Stickney WTP Filter and SCADA Upgrades

MAWSS Project 10391316

February 24, 2026

ADDENDUM NO. 2

9. Questions below received with the following diagram:

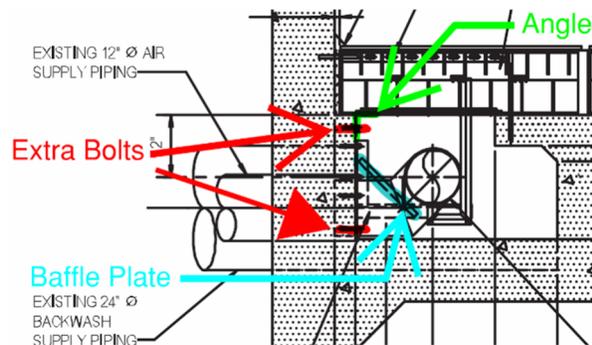
- Are air header and J-risers existing and to remain without replacement?
- Is this SS angle to support blocks existing and remaining or to be replaced?
- What are these 2 extra bolts for? And are they existing and to remain or be replaced?
- Is this a baffle plate existing? If so, is it existing and to remain or does it need to be provided?

Response: The Contractor will be responsible for removing and replacing all incidental accessories, hardware and appurtenances required for the installation of the filter underdrain equipment to provide a complete and operational system. These items should be included as part of the bid price.

SHEET
E-617

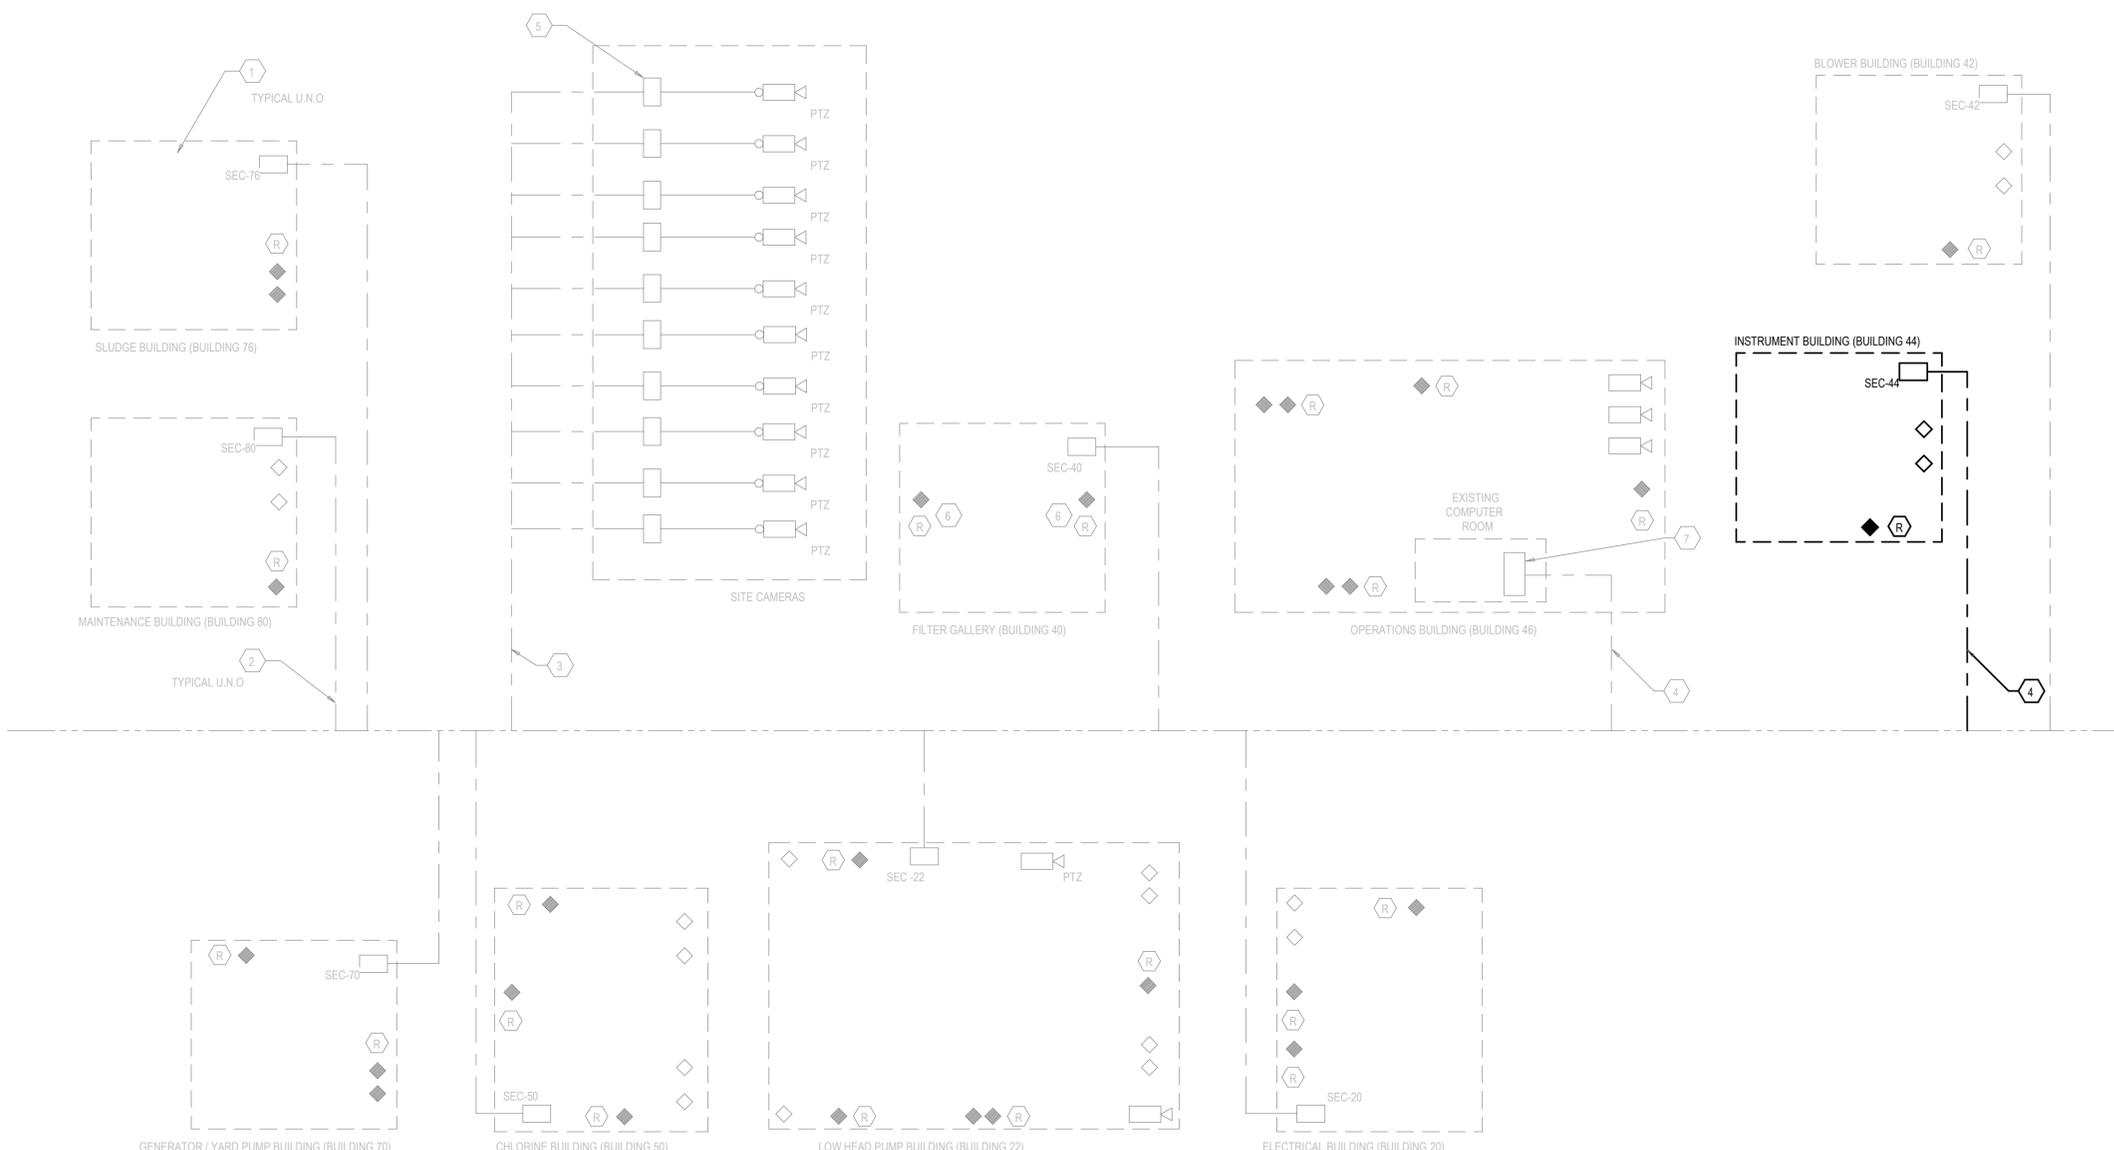
1. Sheet E-617 (See attached Sheet Revision)
 - a. Revised sheet to include additional switch ports for security equipment.

- SECURITY SYSTEM SCHEDULE NOTES:**
- ALL SECURITY HARDWARE SHALL BE COORDINATED WITH MAWSS:
 - A. JOSH EDWARDS, SOLUTIONS ENGINEER, SECURITY ENGINEERING, INC.
 - B. O: 850.484.9300
 - C. C: 850.530.8892
 - D. E: JOSH.EDWARDS@SECENG.COM
 - SECURITY HARDWARE SHALL BE OWNER FURNISHED AND CONTRACTOR INSTALLED.
 - LOCATION OF ALL DEVICES SHALL BE COORDINATED WITH HDR, SECURITY ENGINEERING, INC. AND MAWSS PRIOR TO INSTALLATION.
 - PROVIDE A QUANTITY OF (2) 16 PORT SWITCHES AS AN EXTENSION OF THE EXISTING SECURITY CAMERA NETWORK.
